# **Sydney Construction Materials**

## **Newnes Junction Sand and Kaolin Extraction Proposal**

**Additional information as requested during meeting  
with DIPNR, 23<sup>rd</sup> February, 2005**

**March 2005**

Figure 2 - Detail of visual/acoustic barrier including cross-section A-A for visual transect

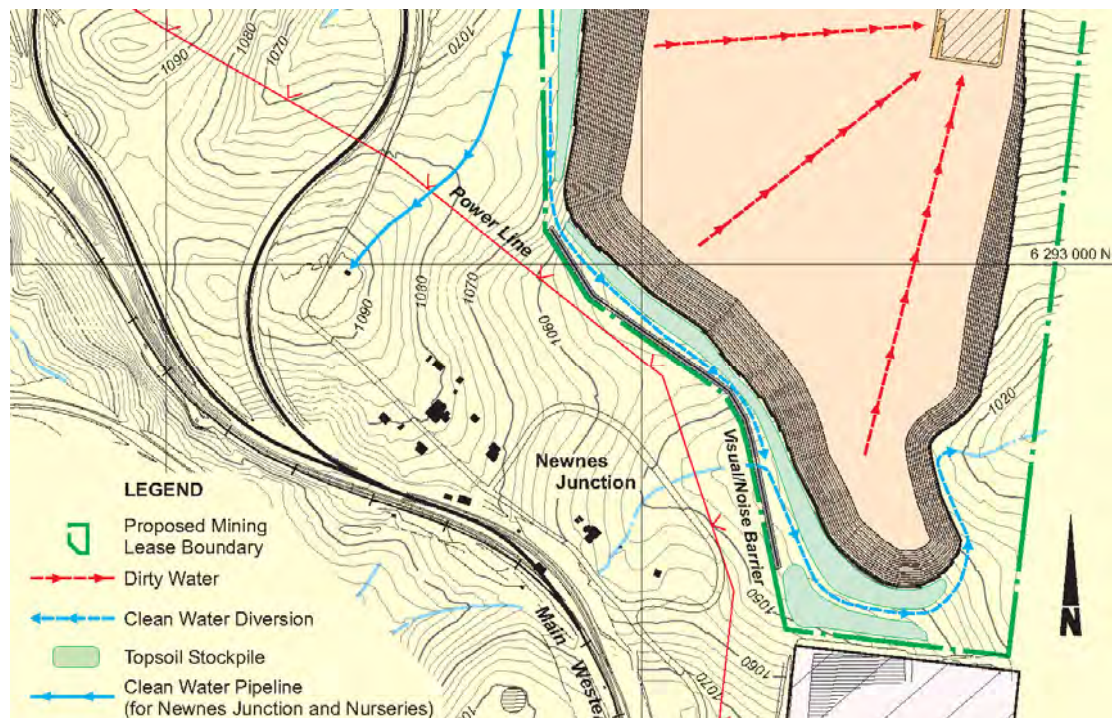
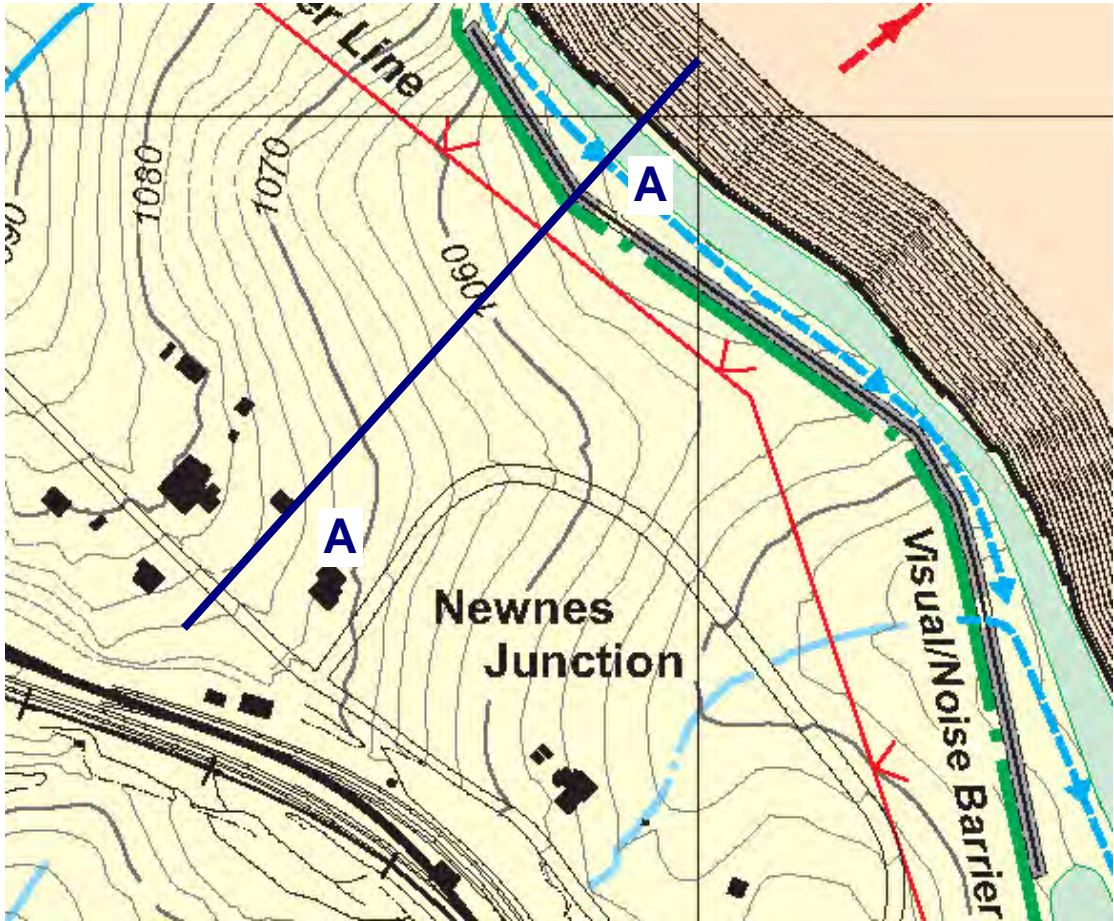
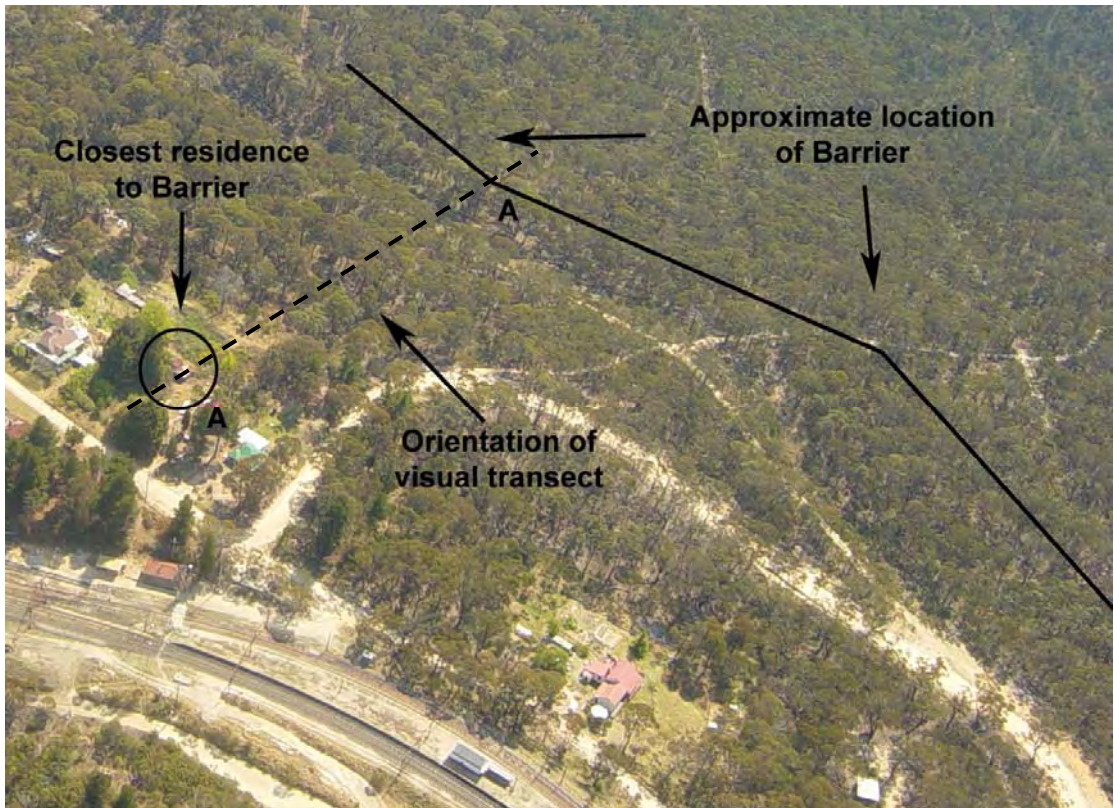
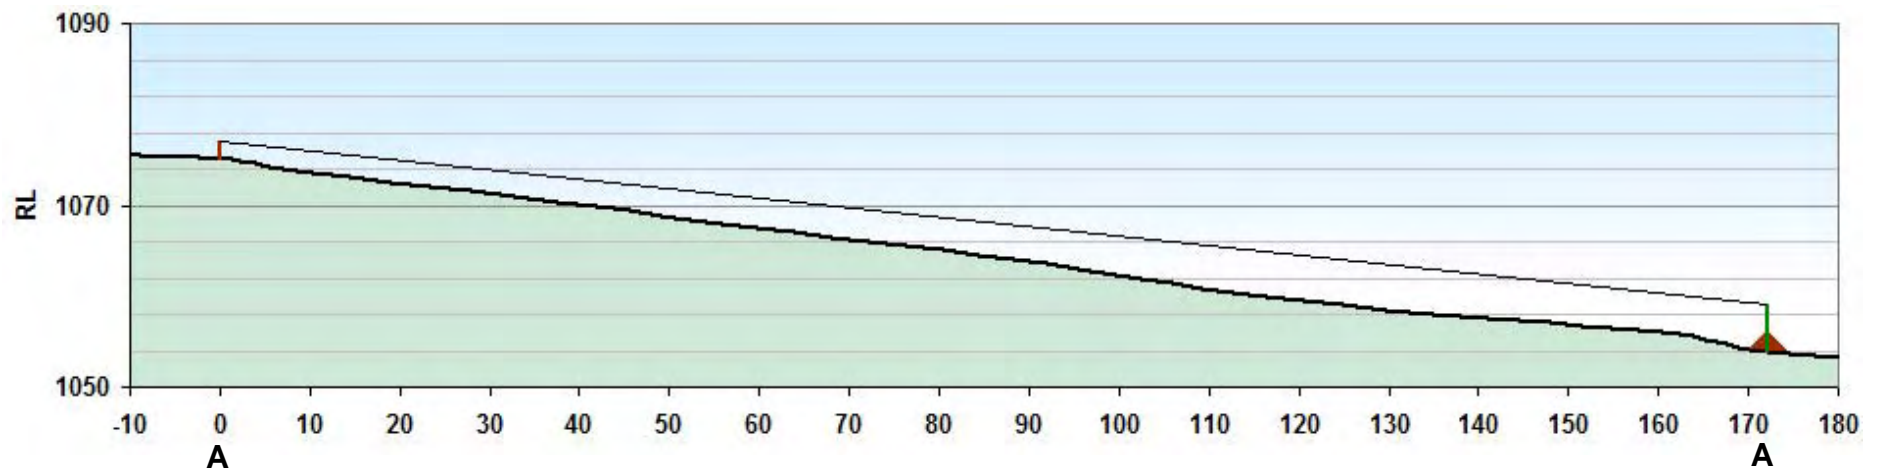
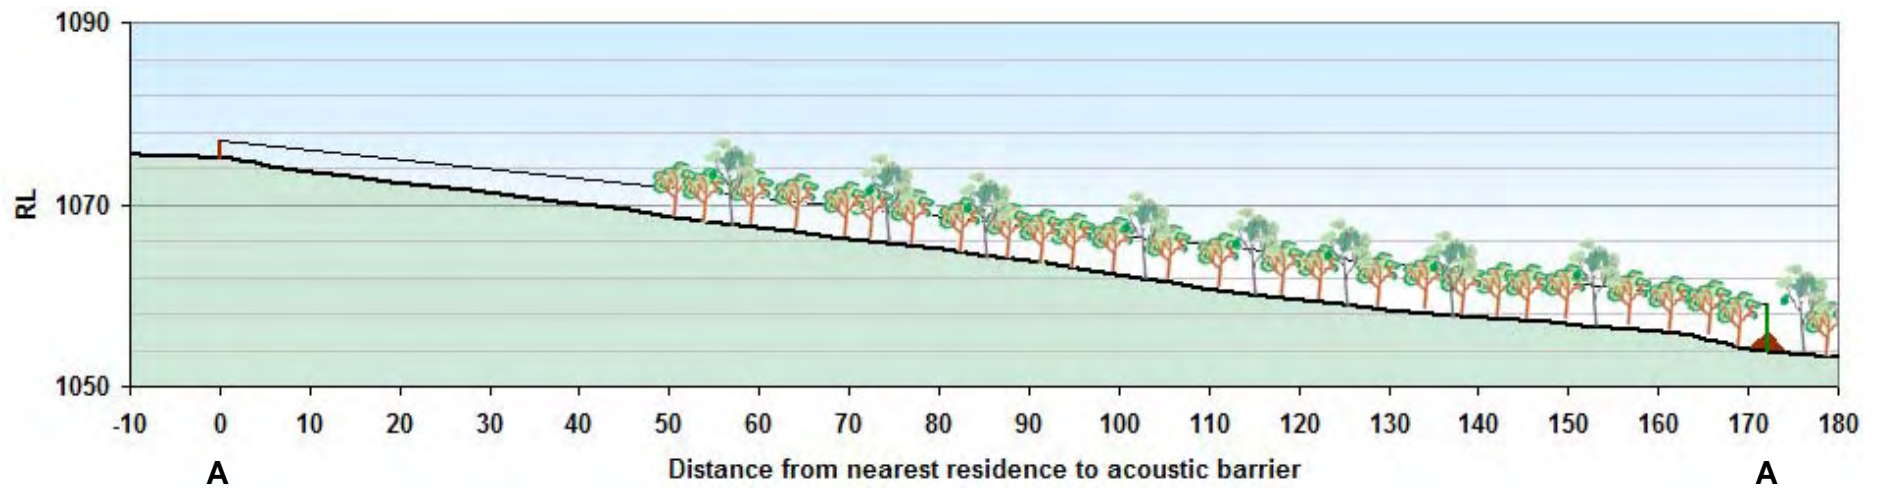
During discussions held with DIPNR (David Kitto and Phil Jones) on 23<sup>rd</sup> February 2005, it was brought to the attention of the Company that it would be necessary to provide an assessment of the visual impact of the proposed visual/acoustic barrier (the “Barrier”) included in the revised quarry design to mitigate visual and acoustic impacts from the proposal.

Figure 1 below provides a plan view of the proposed Project area, including the location and orientation of the Barrier. Figure 2 below provides a detailed plan view of the relationship between the Barrier and the nearest residence, including the location of the cross section A-A. The cross section A-A is depicted in Figure 3, Figure 4 and Figure 5 below.

Investigations by the Company indicate that there will be minimal visual impact as a result of the installation of the Barrier. Examination of Figure 4 reveals that it is quite clear that at 50 metres from the nearest residence, a tree 3 or more metres tall will completely obscure the Barrier for a 2 metre tall person standing at the nearest residence. From Figure 3, it is quite clear that although there is an area of cleared land between the nearest house and the Barrier, there is nevertheless more than 100 metres of established vegetation that will provide adequate visual mitigation. Figure 3 also reveals that the amount of vegetation between the other residences and the Barrier is greater than that between the nearest residence and the Barrier, which means the visual impact from those residences will be equally non-evident.

It is the Company's conclusion that although a 5 metre high visual/acoustic barrier might be expected to have a visual impact on the residents of Newnes Junction, the fact that there will remain over 100 metres of existing vegetation ranging in height to well over 3 metres indicates that there will be minimal, if any, visual impact created by the Barrier at the residences.

Figure 6 - Conceptual design of final landform, including free-draining wetland

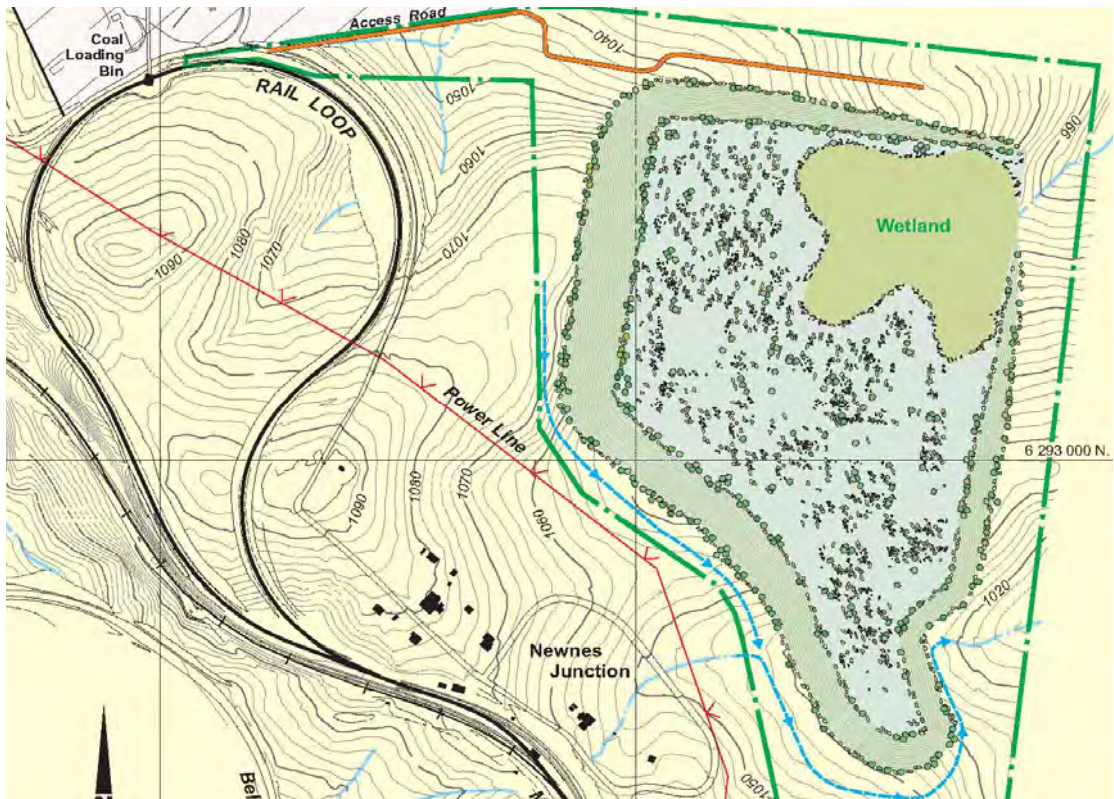
4. **Final Void.** *Please demonstrate the final void is safe in the long term for people and animals. Also assess the impacts of the proposed water impoundment on the ecology of the local area.*

In an attempt to create a visually appealing feature with the final landform of the Newnes Junction project, SCM proposed a shallow lake at the bottom of the development at the conclusion of operations. It was considered that this option would constitute a far more suitable rehabilitation than is currently performed in the extractive industry.

Following discussions with local environmental groups, and taking submissions to the EIS into consideration, SCM altered the final design concept to provide a free-draining wetland at the conclusion of operations rather than a shallow lake (see Figure 6 below). Details of the altered quarry plan and final rehabilitation landform can be found in the "Quarry Plan" by MineConsult Pty Ltd (May 2004). This design, inspired by the nearby Gooches Crater (Figure 7), is in keeping with the surrounding landscape, and will result in a far safer, much more stable environment than the original shallow lake concept.

As water will not pool in the final landform, as it will be free-draining, there will be no risk of over flow or wall collapse during storm events. The quarry wall at the north-eastern corner of the development will be excavated at the end of operations, allowing the to-be-created wetland to drain into the existing drainage. This wetland will act as a natural filter, supplying clean rainwater to the Wollangambe River. Moreover, as water will not be able to pool, there will be no possibility for humans or animals to drown, further increasing the safety of the development's final landform.

Figure 8 - Cross-sectional detail of progressive rehabilitation

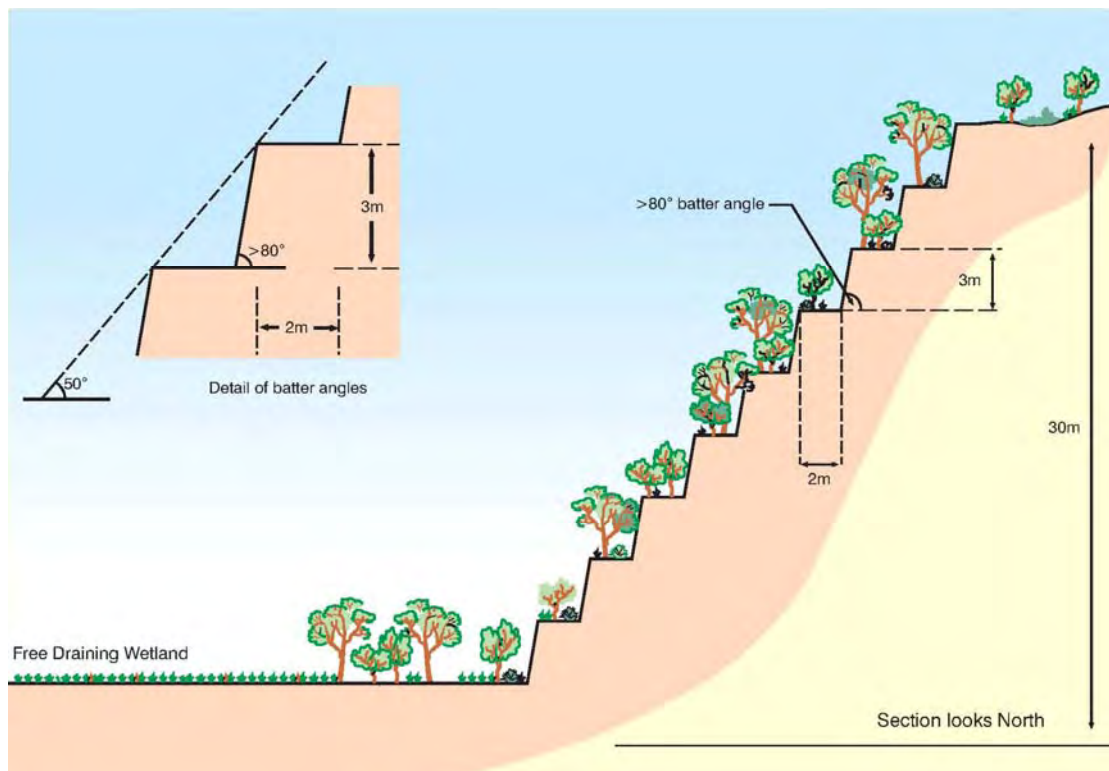
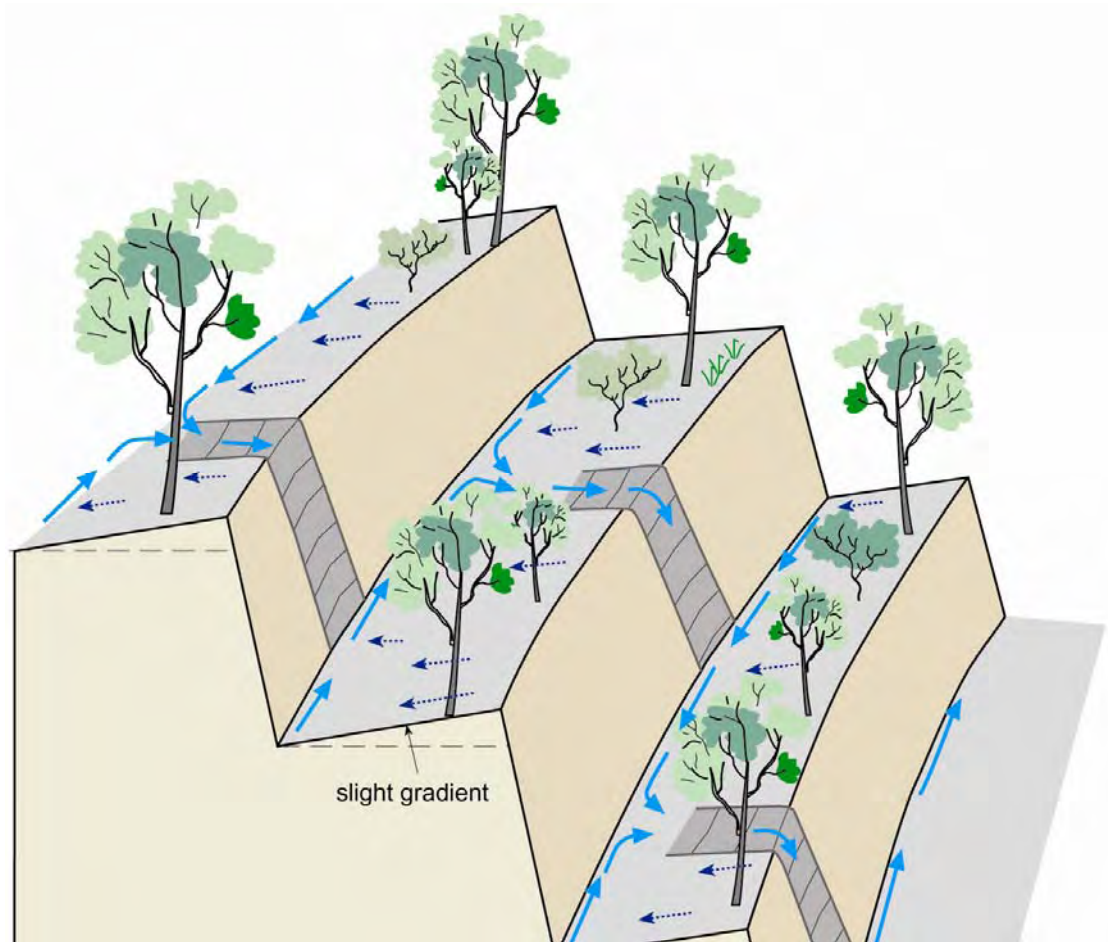
- 17 Concern relating to the proposed width of the rehabilitated slope benches. The conceptual width does not allow mobile plant to access and egress safely and for fall protection of machinery and people. Design for construction and maintenance of benches must be supported by adequate risk assessment of potential hazards.
-

The progressive rehabilitation to be employed throughout operations at the Sydney Construction Materials development will create a series of steps or terraces down the wall of the development. This is done specifically so as to provide benches on which native vegetation will be planted to enable the site's rehabilitation and visual integration, but also provides a significant safety feature for the development (see Figure 9 below).

As can be seen in Figure 8 below, these benches will be left every 3 vertical metres down the development wall. By growing native vegetation on these benches, the walls of the development will be stabilised, preventing erosion or collapses. In addition, the visual impact potentially created by such a development can be effectively eliminated, by providing a green, vegetated wall. The slight gradient of the benches towards the wall (see Figure 10 below) will provide further safety and landform security by promoting the motion of loose objects towards the wall. By slowing the flow of water over the edge, this feature will also contribute to the slowing of potential erosion. Moreover, by placing a 2 metre wide bench every 3 vertical metres, the distance a person could potentially fall is significantly reduced to just 3 metres. Other quarries in the area, and indeed other natural landforms, do not provide similar such levels of safety, with some permitting potential falls in excess of 20 metres. Further details on the design of the terraced landscaping can be found in section 6.2 of the Soil and Water Management Plan prepared by GSS Environmental (October 2004).

The terrace design (see figure 3.14, Sydney Construction Materials, EIS, May 2003, reproduced in Figure 10 above) illustrates the slight gradient of each terrace directed back to the pit wall. This provides both for optimum water retention on the ripped surface of the bench and also is a safety factor, which inhibits loose material falling down the terraces into the active pit during mining operation.

Figure 11 - Map of drill hole locations

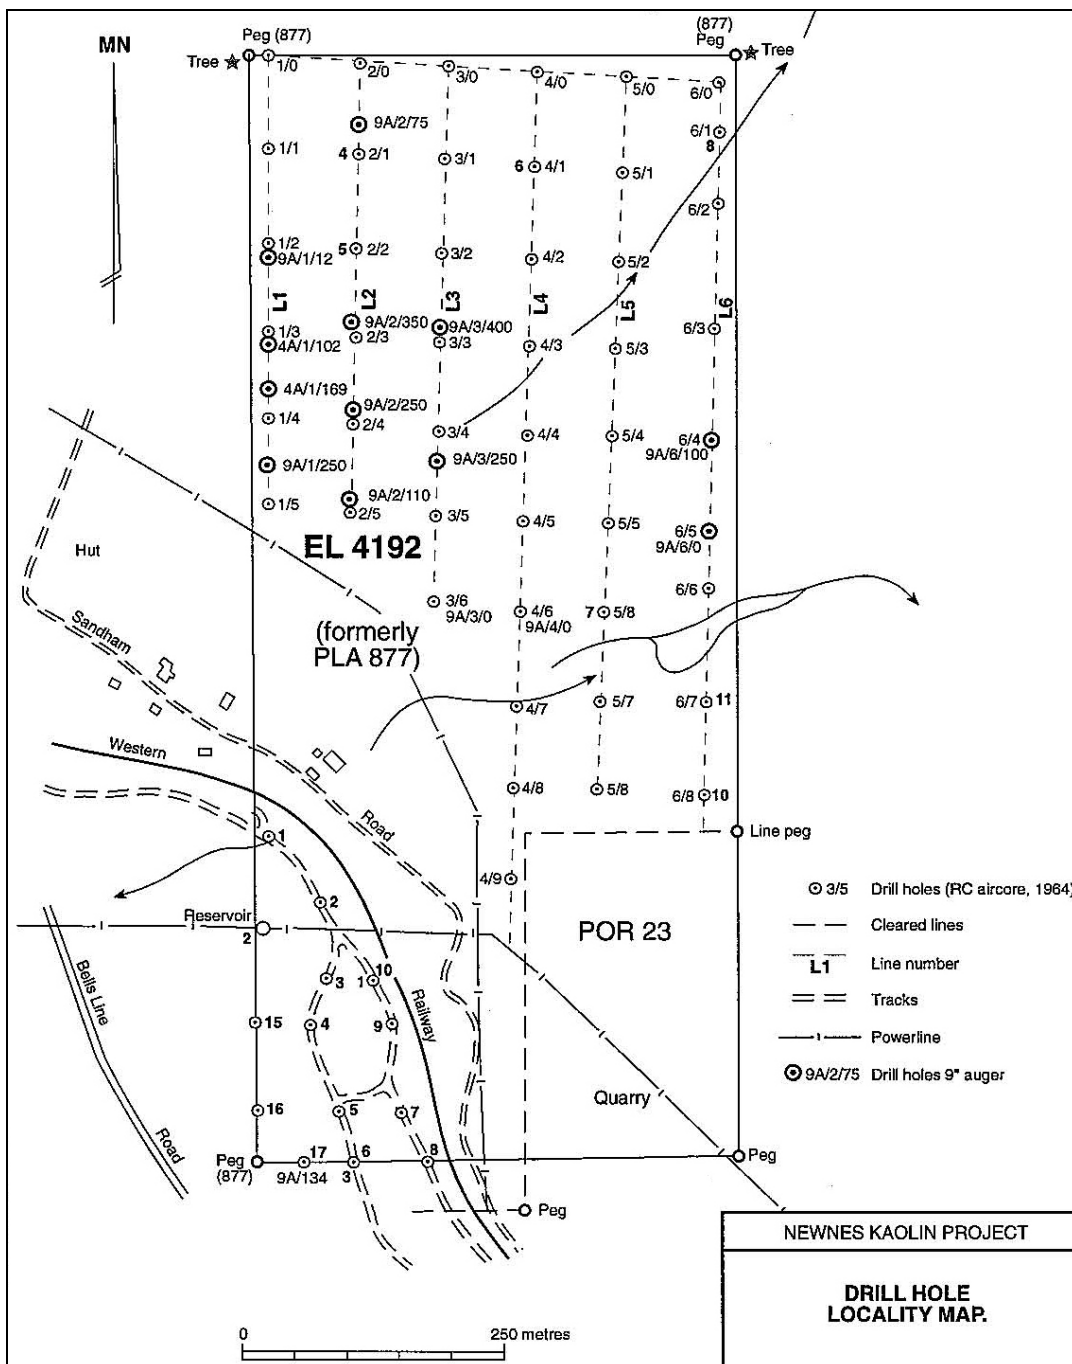
| Issue # | Issue Summary  |
|---------|--|
| 2       | No map showing drill-hole locations.   |

The resource over this area is classed as estimated reserves, whilst the resource over the eastern area is classed as probable reserves. It is however acknowledged that until finalisation of the JORC code analysis, these reserve classifications remain tentative even though there are no changes anticipated in the outcome. JORC code analysis, however, is not required for the Development Application process.
